KEY ISSUES

3.1 INTRODUCTION

This Chapter provides a discussion of four topic areas that are the focus of many of the comments on the Draft EIS. These include (1) Draft EIS alternatives and a lower density alternative; (2) density calculations and characterization; (3) the Residential Market designation in the City's Comprehensive Plan; and (4) potential mitigating measures for aesthetics impacts. For each of these topics, this Chapter provides expanded discussion, corrections and/or clarification, as applicable. In addition, this introduction includes a brief discussion of the purpose of an EIS as established in the SEPA Rules.

Draft EIS Figure 3.1-8 Multifamily Densities

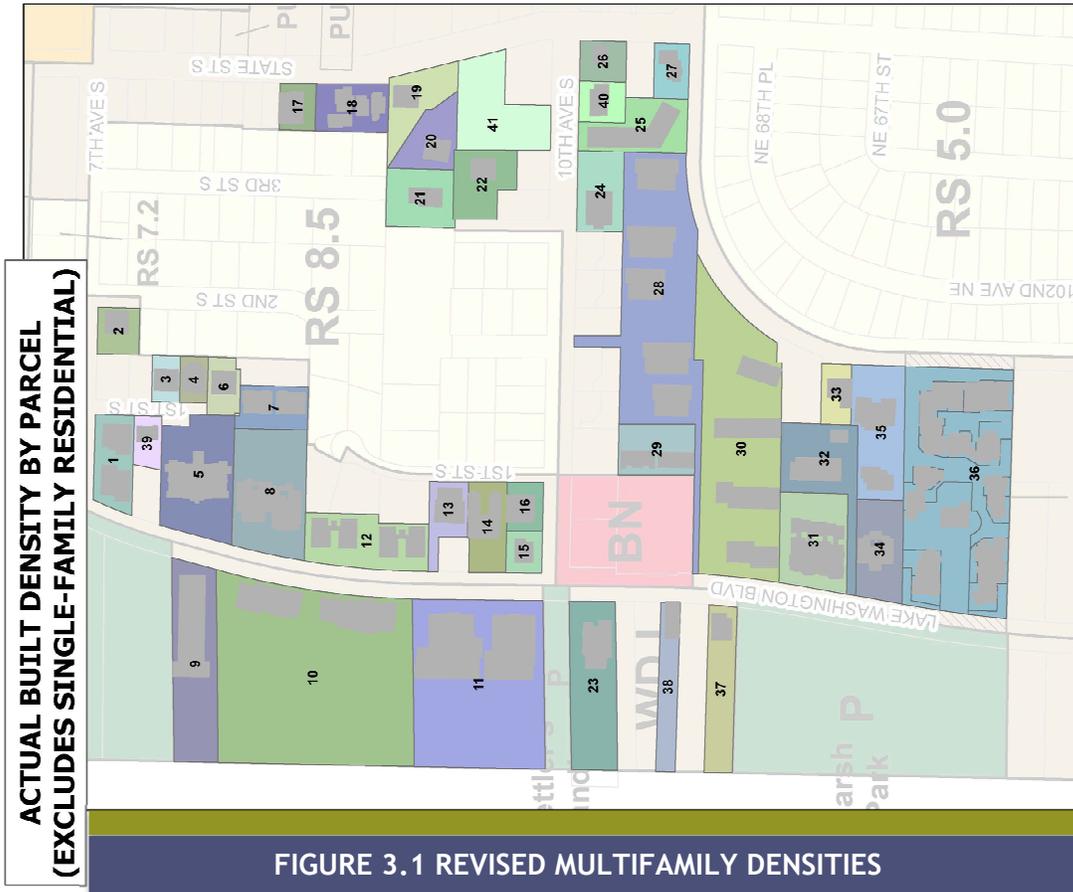
A number of Draft EIS comments focus on Draft EIS Figure 3.1-8 Multifamily Densities. Comments on the table discuss (1) errors in the table; and (2) the calculation of density for development along the Lake Washington shoreline. In addition, several comments questioned the characterization of the study area as primarily multi-family. Each of these topics is addressed below.

Several comments describe missing and incorrect density information in the table and provide additional data. Based on City review of the comments, the figure has been corrected and is shown as Final EIS Figure 3.1. Deleted information is crossed out (XXXX) and inserted information is underlined in red (XXXX).

A number of Draft EIS comments question the density calculations along the Lake Washington shoreline, stating that lot sizes shown in Figure 3.1-8 are inaccurate. For example, Draft EIS Figure 3.1-8 shows that Lot No. 9 has a site area of 9,343 square feet and 38 residential units, resulting in a calculated density of 177.2 units/acre. Draft EIS comments identify a lot area of 41,436 sf, for a resulting density of 39.9 units/acre. Similar concerns are raised regarding the density calculations for Lots 11, 23, 37 and 38. Please see the highlighted rows in Final EIS Figure 3.1 for the shoreline lots.

As shown in Figure 3.1, the changes make three corrections to existing entries and add three new entries. Of the three existing entries, the corrected density is increased in two entries and decreased in one entry. The three additional entries are for relatively small multifamily uses, with densities ranging from 9.8 to 12.4 units/acre. Taken as a whole, these corrections do not change the discussion of this figure in Draft EIS Section 3.1 (Land Use).

Data used by the City to calculate lot area comes from the King County Department of the Assessor (see Appendix A). For the purpose of calculating density, the difference between the City and Draft EIS commenter lot size assumptions comes from whether dry land only or both dry land and water area are used as the basis for determining lot size. With respect to Lot No. 9, the Draft EIS states that the existing development was constructed when the lakebed area was allowed to be included in the density calculation. Since adoption of the Washington Shoreline Management Act in 1974, the City does not permit overwater structures and uses only the upland (dry land) area to calculate density.⁴ Accordingly, the densities shown in Draft EIS Figure 3.1-8 are calculated based on dry land area, without regard for water area. Draft EIS comments state that the density calculation should be based on total (land and water) site area as shown in the King County Assessor's parcel information. Table 3-1, below, illustrates the difference in site area and density calculations for the affected sites.

Figure 3.2. Parking Demand by Land Use Type - Mixed Residential and Office

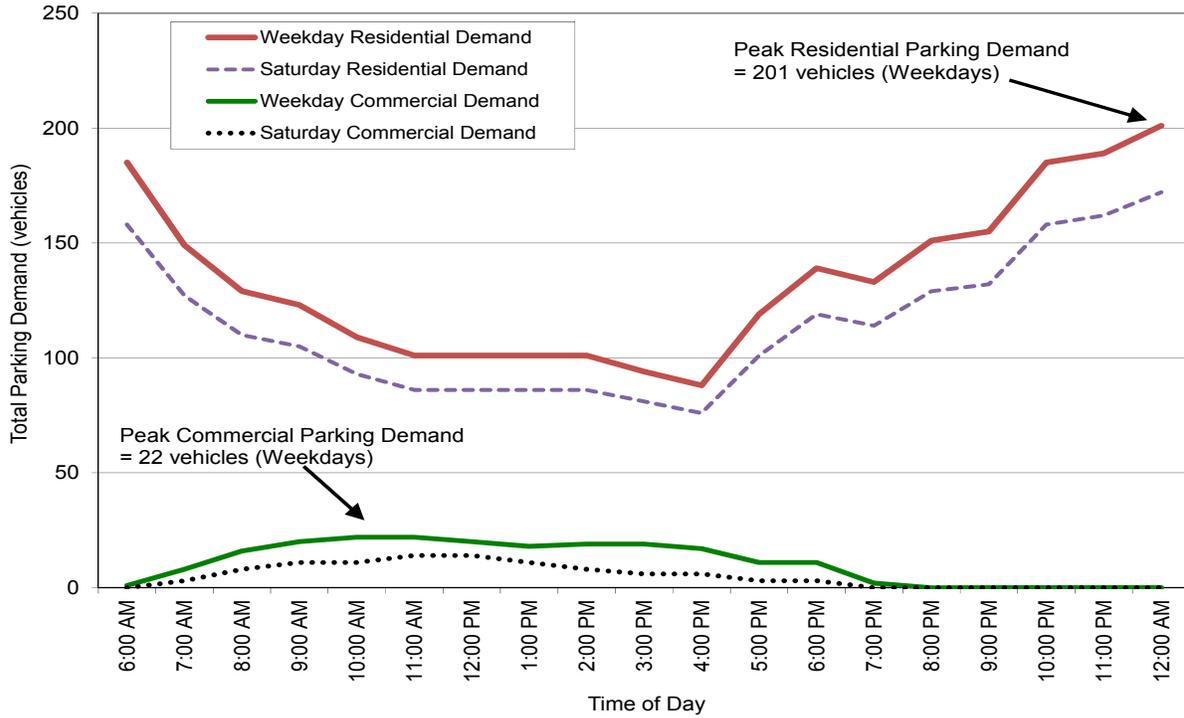
Figure 3.2 shows the projected weekday and Saturday parking demand by time of day for each of the residential and office uses. As shown, the peak parking demand for residential and office components would not occur simultaneously -- peak parking demand for residential uses occurs overnight while peak parking demand for office uses occurs mid-morning. Figure 3.3 shows the projected weekday and Saturday parking demand by time of day for the combined uses. Based on these figures, the combined peak parking demand for the project with the office use scenario for the commercial space is estimated at 201 vehicles and is expected to occur overnight between midnight and 6:00 A.M.

Figure 3.3. Combined Parking Demand - Mixed Residential and Office

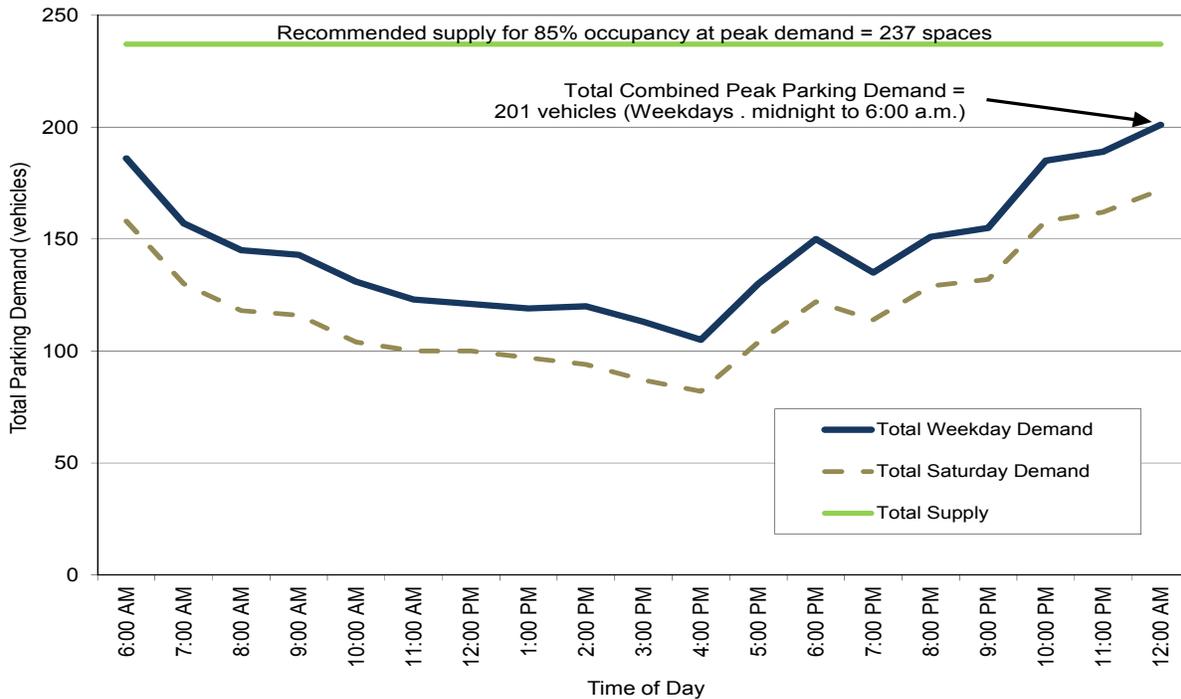
To provide a buffer supply that would help reduce on-site circulation while drivers search for parking, accommodate daily and hourly fluctuations in demand, and accommodate excess visitor demand, the recommended supply for this scenario is 237 spaces. This recommended supply is based on a peak cumulative demand of 201 vehicles at 85% utilization ($201 \text{ spaces} / 0.85$), also shown on Figure 3.3.¹¹

Figure 3.4. Parking Demand by Land Use Type - Mixed Residential, Retail and Restaurant

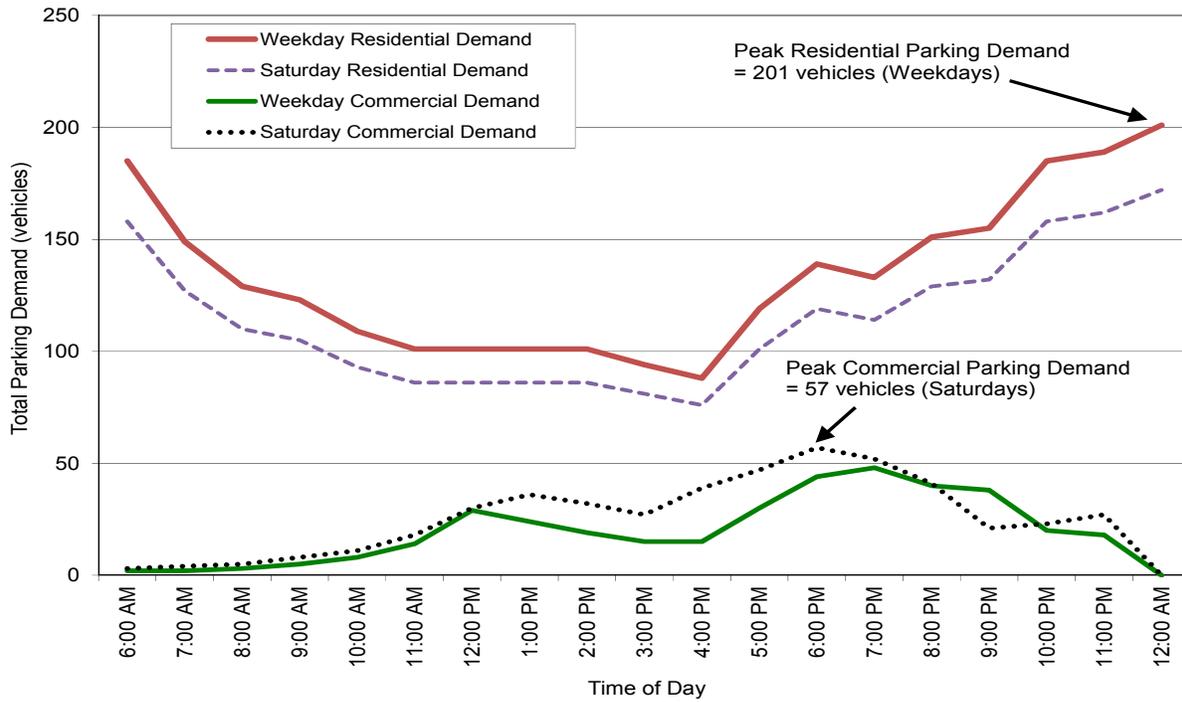
Figure 3.4 shows the projected weekday and Saturday parking demand by time of day for each of the residential and retail/restaurant uses. Similar to the previous office scenario, the peak parking demand for the residential and retail/restaurant components would not occur simultaneously -- peak parking demand for residential uses occurs overnight, while peak parking demand for retail and restaurant spaces occurs during early evening. Figure 3.5 shows the projected weekday parking demand by time of day for the combined residential and retail/restaurant uses. Based on these figures, the combined peak parking demand for the project is estimated at 207 vehicles and is expected to occur between 11:00 P.M. and midnight, when the residential demand would be near its peak and some remaining demand from the restaurant use would be on site.

Figure 3.5. Combined Parking Demand - Mixed Residential, Retail and Restaurant

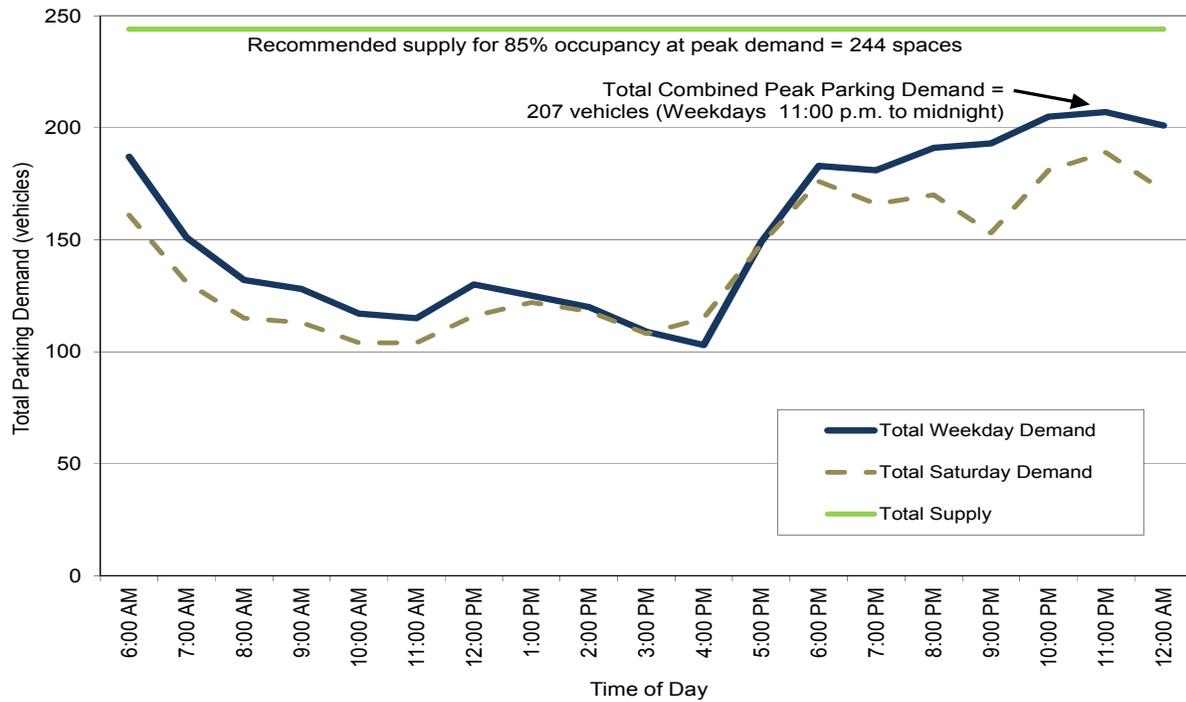
To provide a similar buffer supply as described for the prior scenario, a minimum parking supply of 244 spaces ($207 \text{ spaces} / 0.85$) would be recommended to accommodate parking demand if the commercial space is developed as retail and restaurant. This recommended supply for the project as mixed residential and retail/restaurant is also shown on Figure 3.5.

Based on the analysis presented above, and assuming shared parking, a minimum of 244 spaces is recommended to accommodate the typical peak parking demand of the proposed Potala Village mixed-use project. A supply of 244 spaces is projected to accommodate the typical peak parking demand generated by residential uses combined with either office or retail/restaurant uses and would also provide a buffer supply to accommodate daily fluctuations, excess visitor demand, and to minimize driver circulation.
